**NUMBER:** 08-001-12

Temporary Loss Of ABS/ESP Functionality

Rerouting ABS power feed circuit in the front PDC from fuse 14 to fuse 6

2011 - 2012 (LD) Charger (Police Only)

**Fig. 4 Terminal Retainer Location**

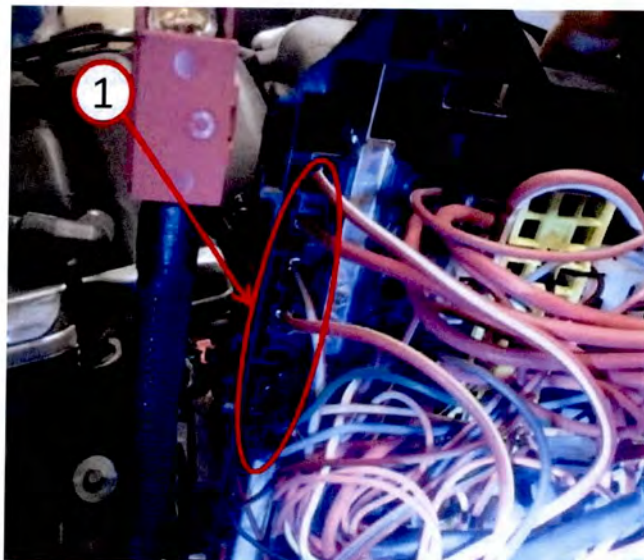
- 
8. From bottom side of PDC, remove black rear terminal retainer (Fig. 4) using a flat pick tool (Located between fuse location's 2 through 8), and discard.

**Fig. 5 Blade Terminal Installation**

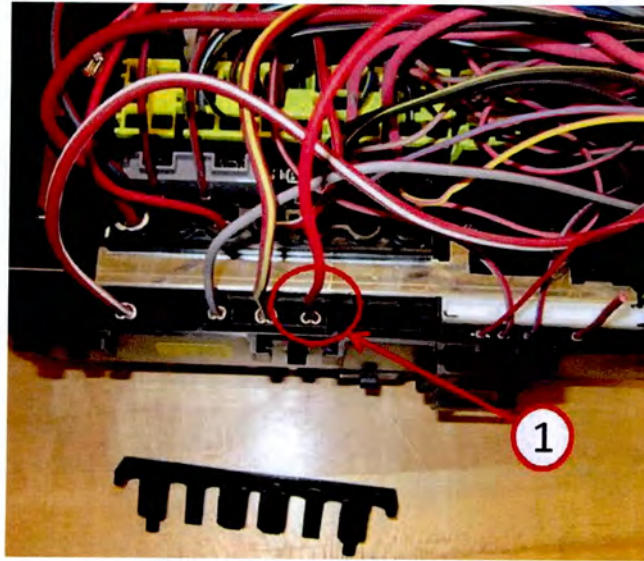
9. From service kit insert the blade terminal pig tail into cavity 6B (fuse 6) and ensure you hear the terminal click into place (Fig. 5). Pull to verify engagement.

**Fig. 6 Terminal Retainer Installation**

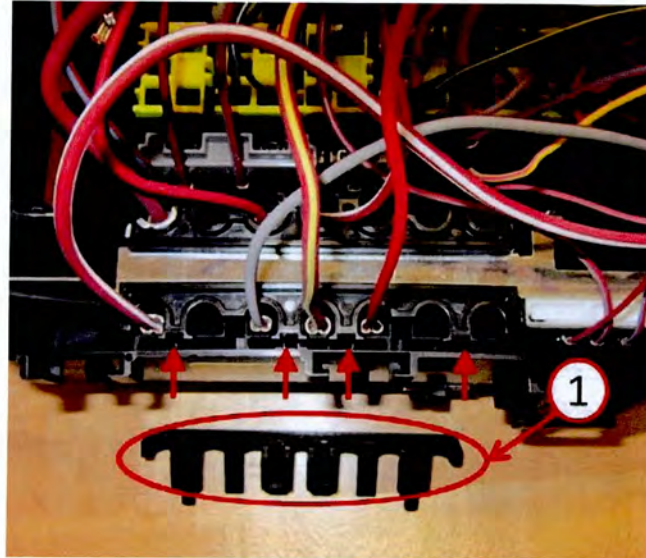
- 
10. From service kit, insert new Black rear terminal retainer back into the correct position (Fig. 6).

**NOTE: Verify 4 clicks are heard for check point (Do Not Re-use original retainer).**

**Fig. 7 Fuse 14 Terminal Elimination**

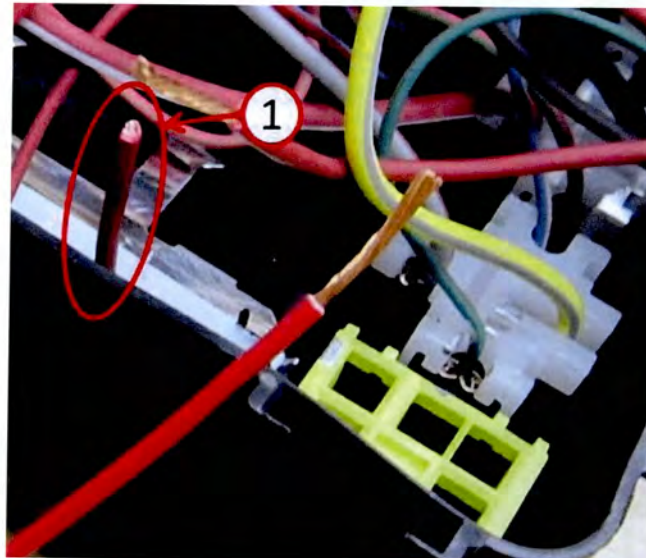
11. Locate the A902 RD circuit from cavity 14B (fuse 14) on the bottom of the PDC.
12. Approximately 35mm from the back of the terminal crimp, cut the circuit with wire cutters (Fig. 7). This circuit will no longer be used.

***Fig. 8 Fuse 14 Terminal Protection***

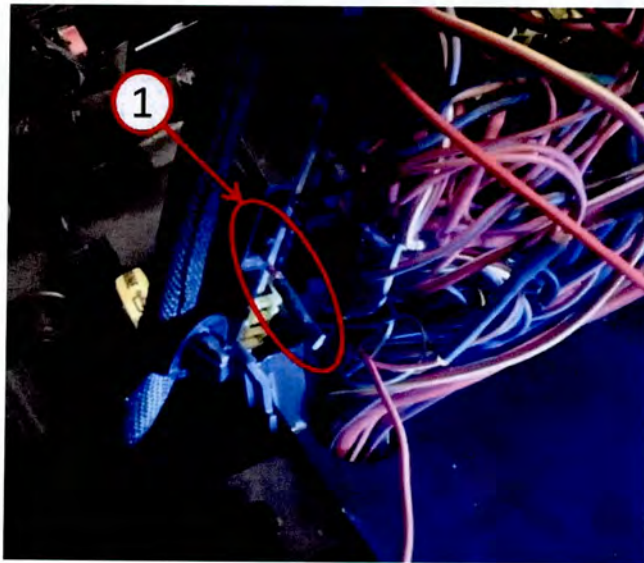
13. From service kit, take the black 25mm heat shrink tube and place it over the end of the wire protruding from the PDC to seal the un-used circuit (Fig. 8). Heat evenly to seal properly.

**NOTE: Visible glue on both sides are an indication of a good seal.**

**Fig. 11 Splice Band Installation**

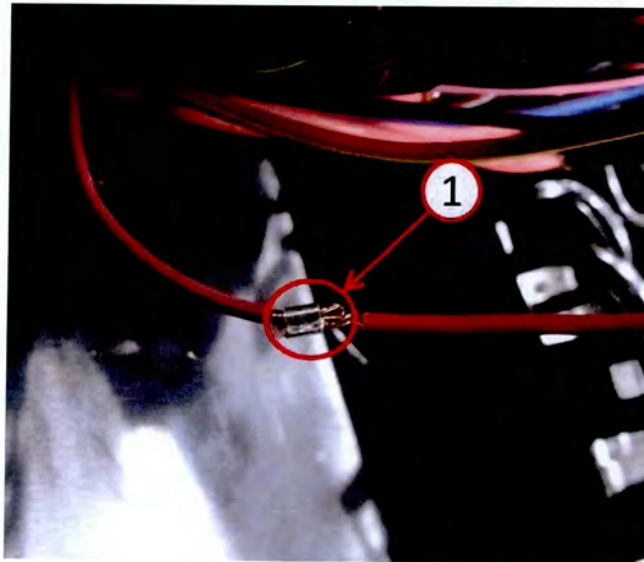
16. Holding the installed pig tail and the remaining portion of the cut circuit together, use splice band from service kit and crimp using "B Style" Crimping Tool from essential tools (Fig. 11).

***Fig. 12 Splice Soldering***

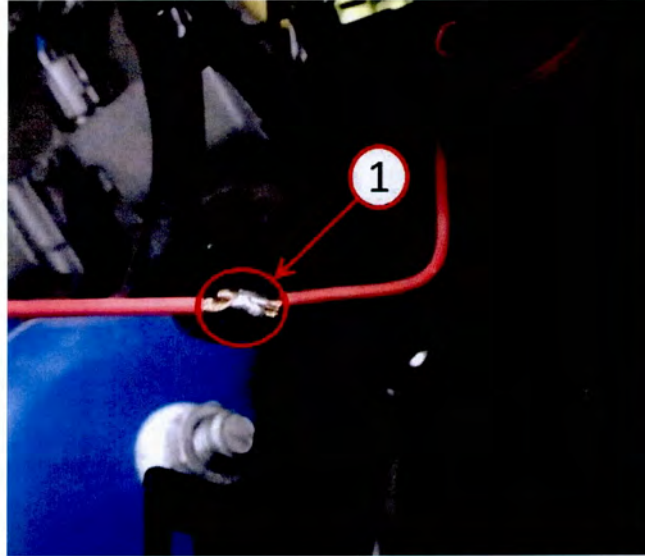
- 
17. Apply lead-free solder to the crimp (Fig. 12). Avoid accidentally heating up the heat shrink tube in the process

**Fig. 14 Fuse Installation**

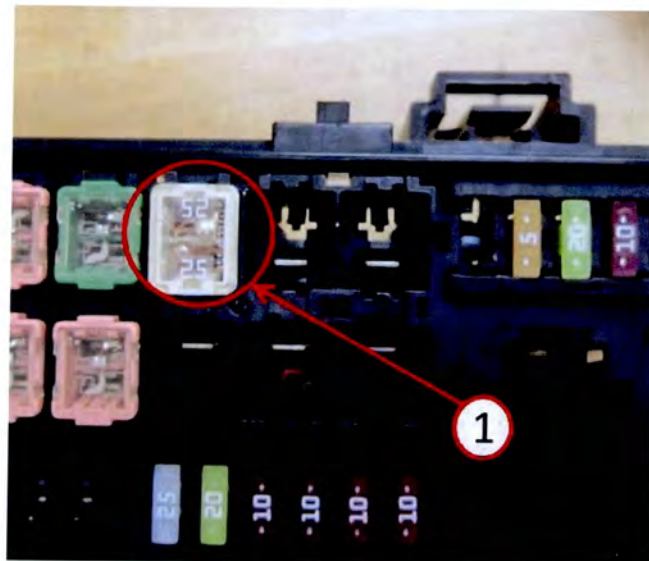
19. Verify 10 gauge circuits are not broken (visual inspection).
20. Reinstall the lower PDC cover: Align all 9 clips; push on cover to seat. Ensure no wires are pinched between bottom cover and the PDC.
21. From Service kit insert the 25 Amp White Fuse into fuse location 6 (Fig. 14).

**Fig. 15 Continuity Check**

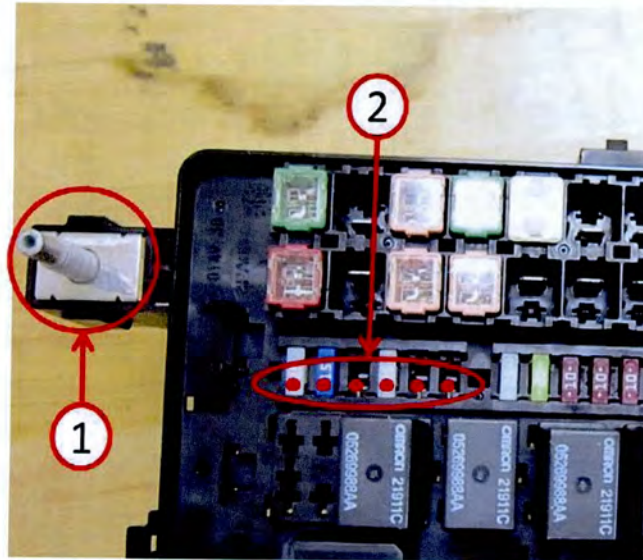
22. Connect wire harness and check for continuity, using multimeter. Place one probe on the B+ stud of the PDC. With the other probe verify continuity with cavities 28 through 33, 0 ohms for all test points(Fig. 15).

**Fig. 16 Fuse Identifier Installation**

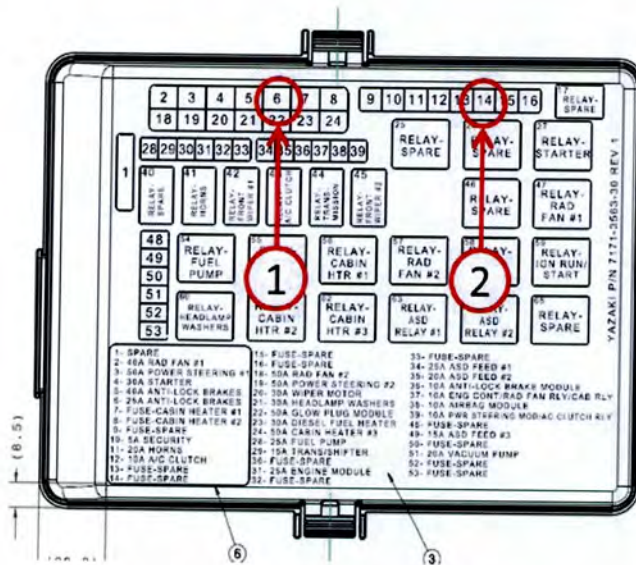
- 
23. Reinstall the PDC back onto the bracket (3 tabs).  
24. Place revised fuse location stickers on PDC box to indicate change of fuse location (Fig. 16).  
a. Sticker 14 goes in number 6 location.  
b. Sticker 6 goes in number 14 location.
